## City of Lewisville, TX

### Planning and Zoning Commission Regular Session Agenda

**TO:** Planning and Zoning Commission  
**FROM:** Michele Berry, Planning Manager  
**DATE:** June 2, 2020  
**SUBJECT:** **Preliminary Plat of Heritage Towers Addition; Lots 1X, 2X, 3 and 4X, Block A; on 22.33 Acres out of the Steven Riggs Survey, Abstract Number 1088; Zoned Planned Development – Mixed Use (PD-MU) District; Located on the West Side of Summit Avenue Approximately 1,000 Feet South of Justin Road (F.M. 407), Being a Replat of Lot 2, Block B, Lewisville Corporate Center Addition.**

**PRELIMINARY PLAT FOR HERITAGE TOWERS ADDITION**

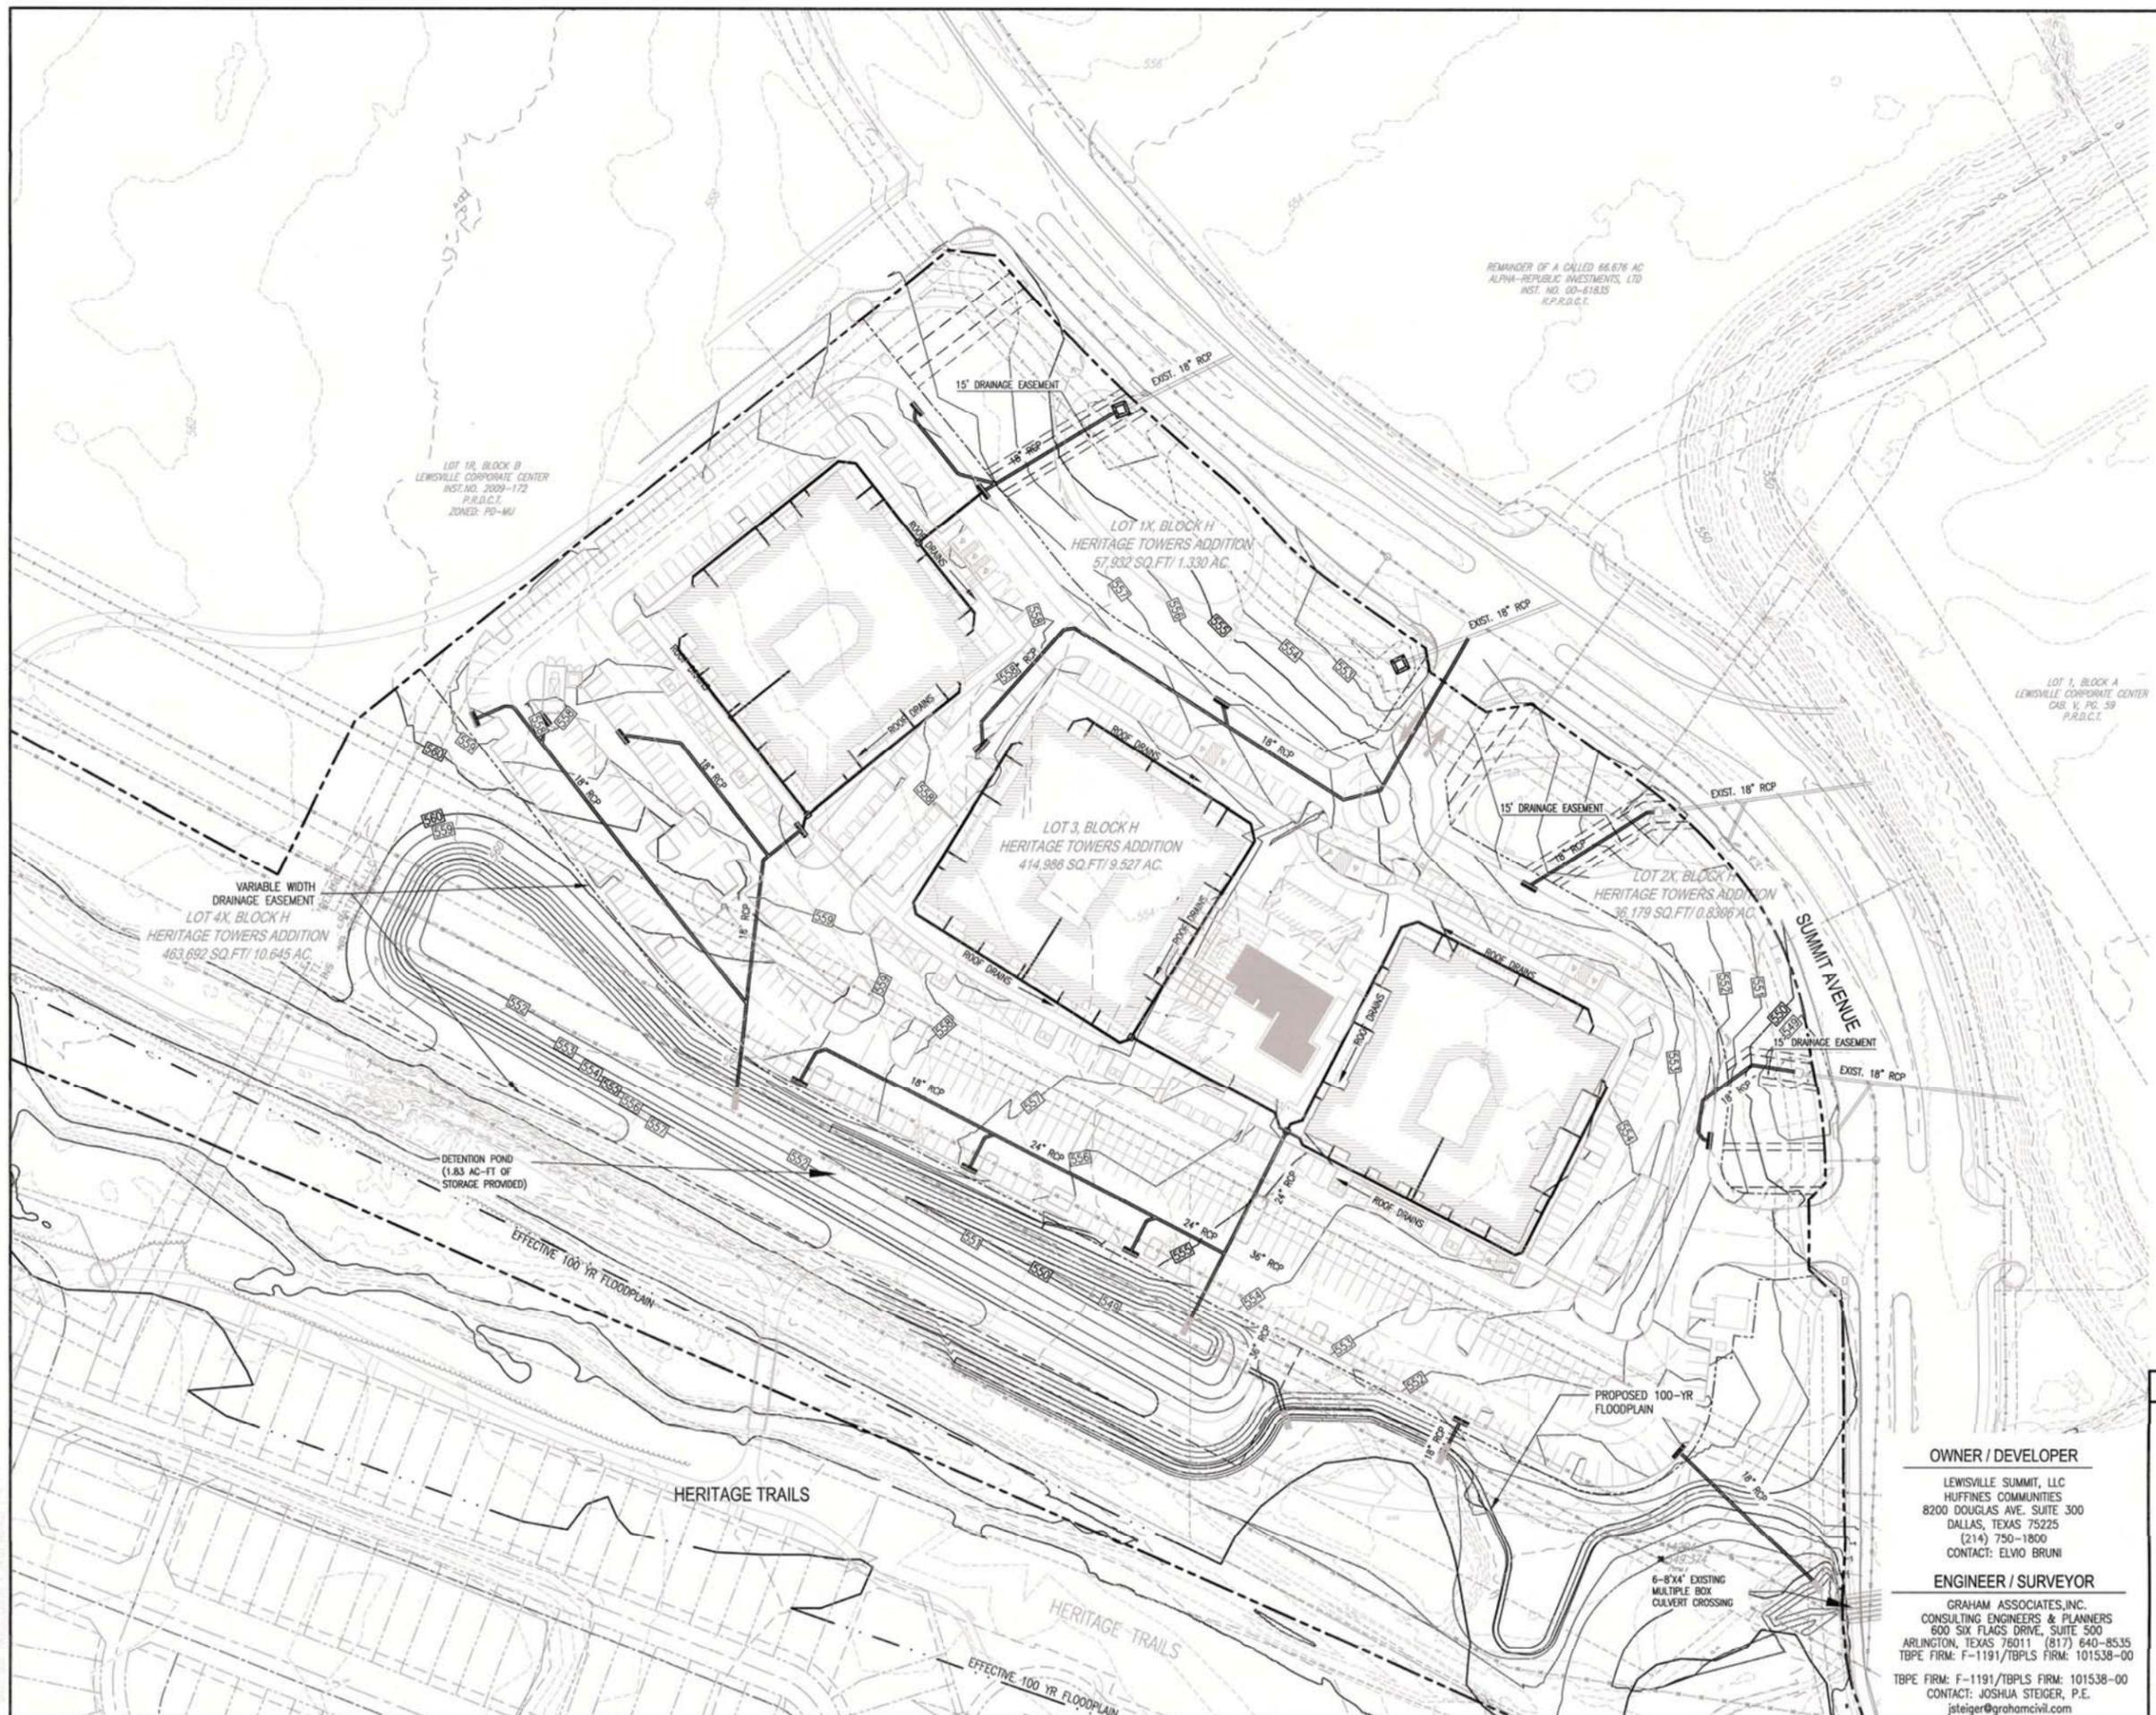
Will the flow line work if you connect to the souther SD line? Or could it work with a slight grade change?

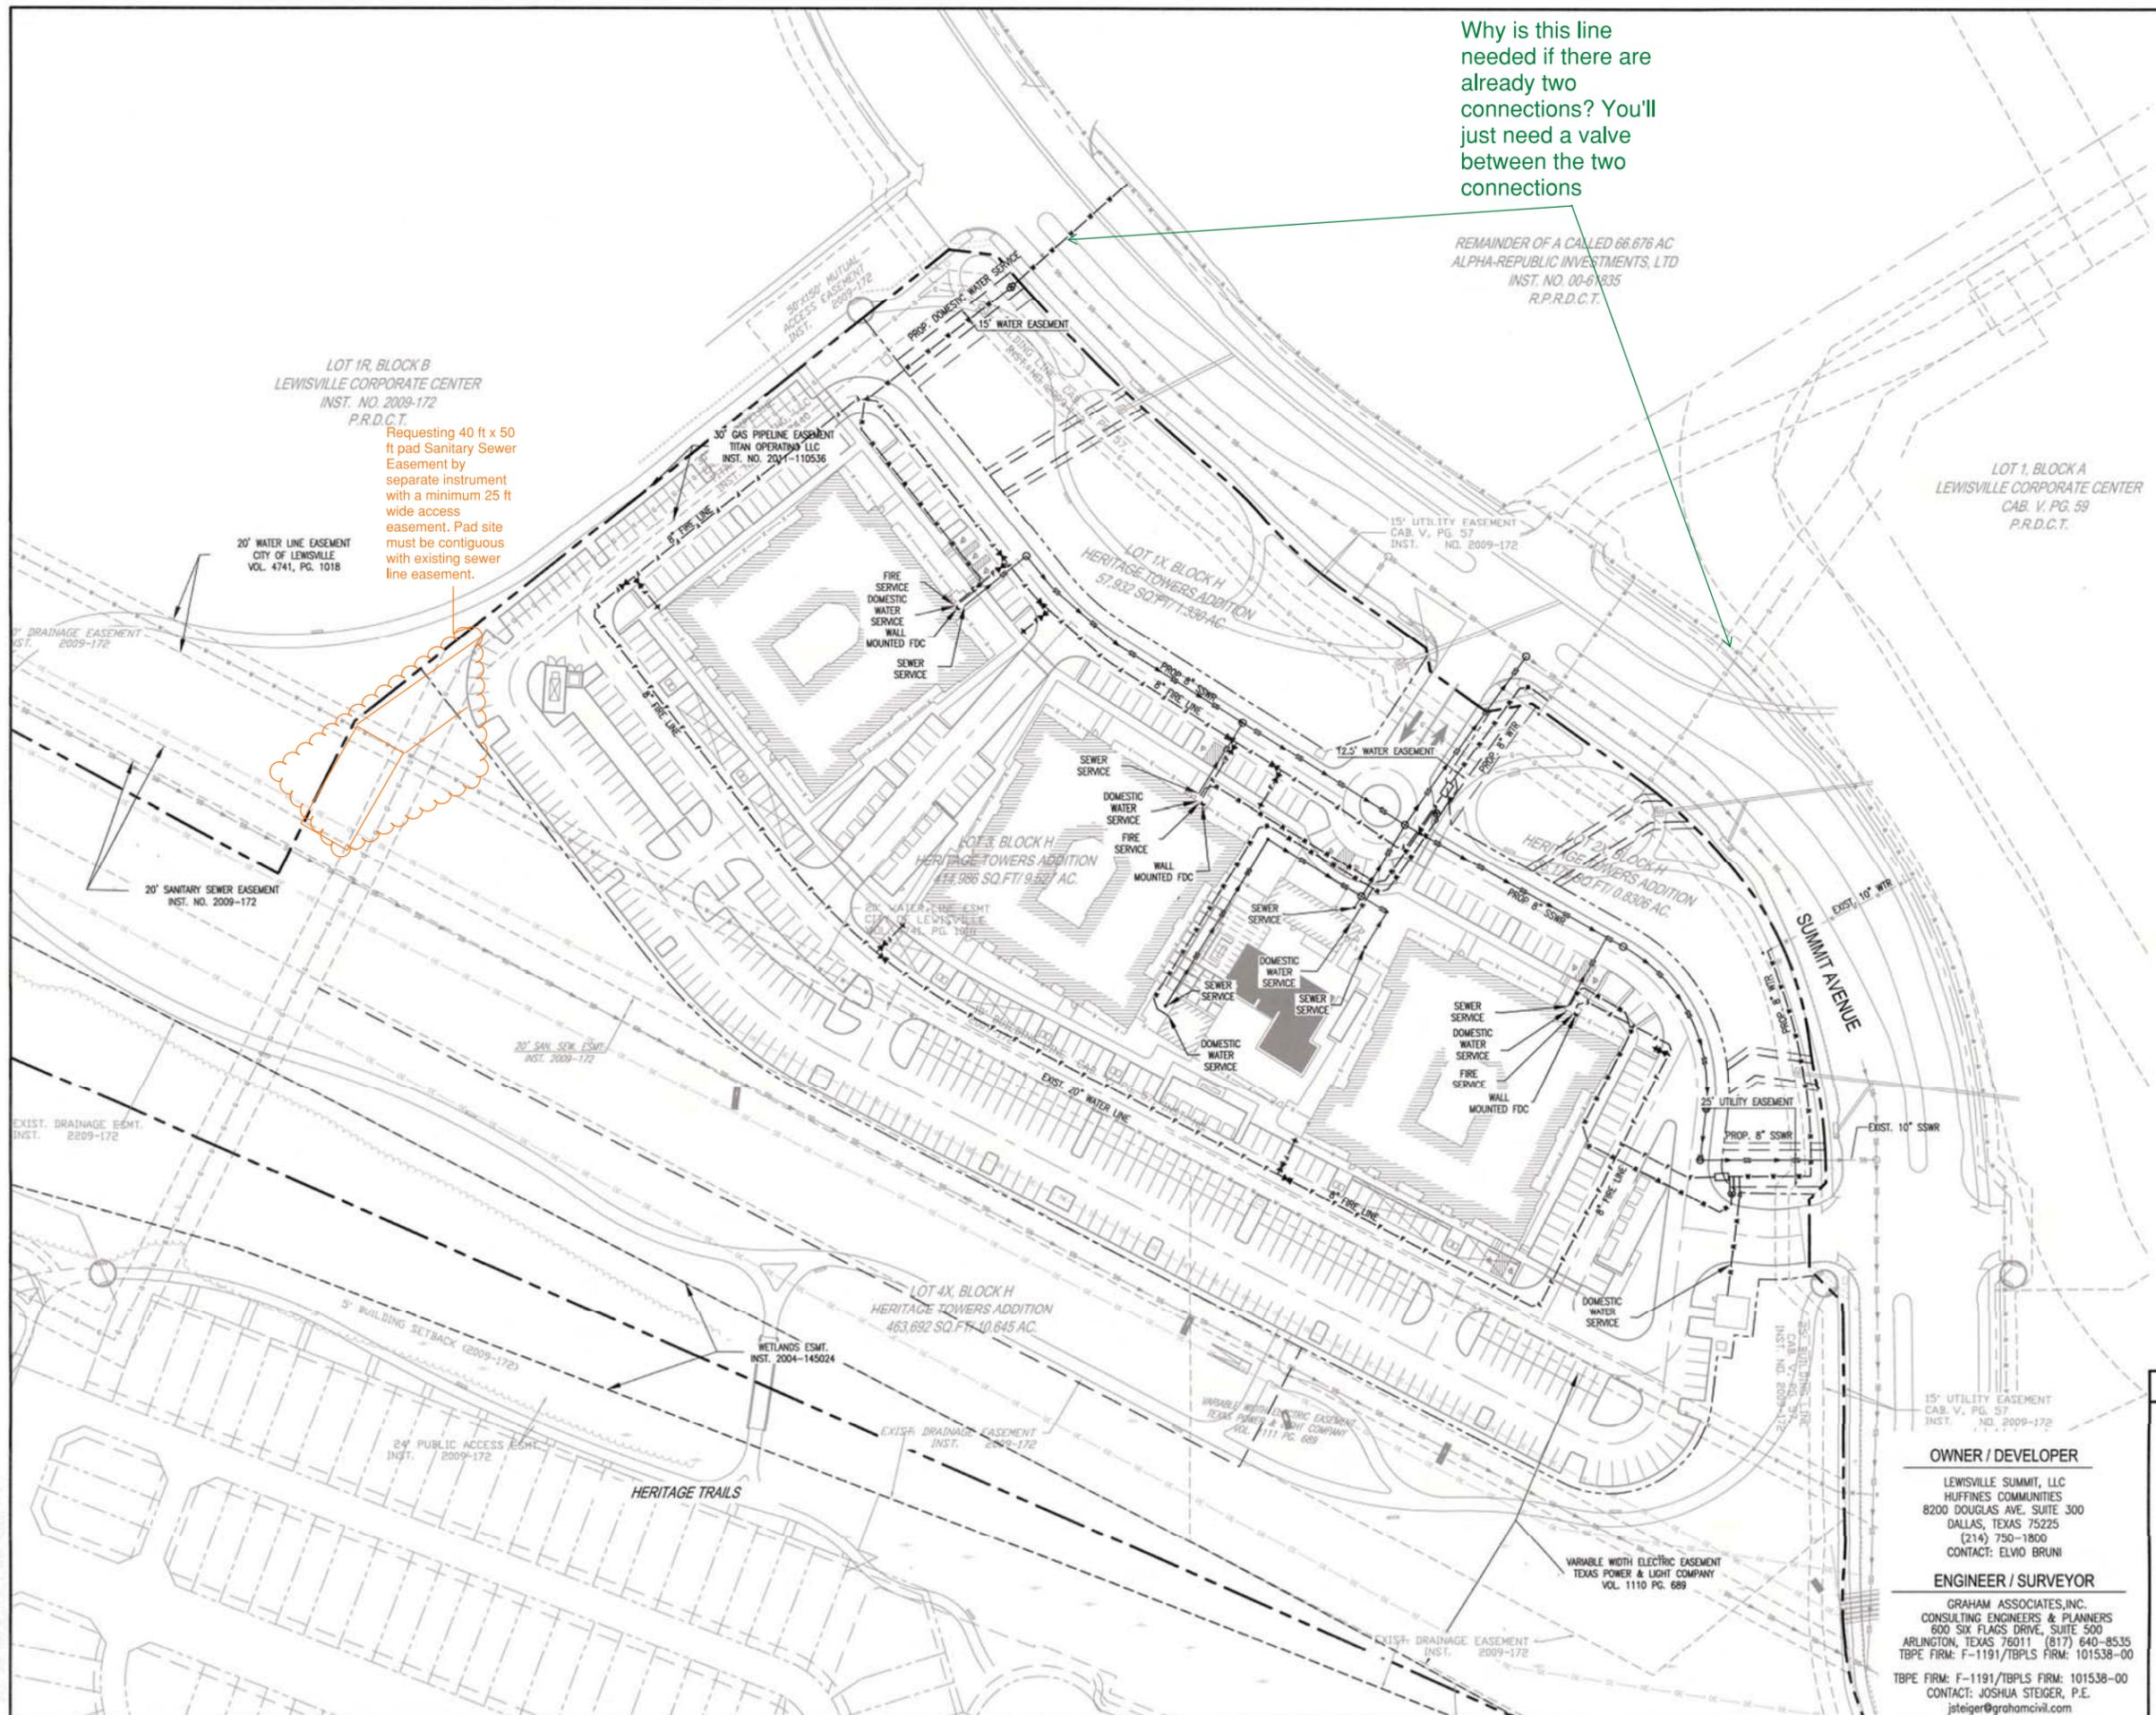
Will the flow line work if you connect to the souther SD line? Or could it work with a slight grade change?
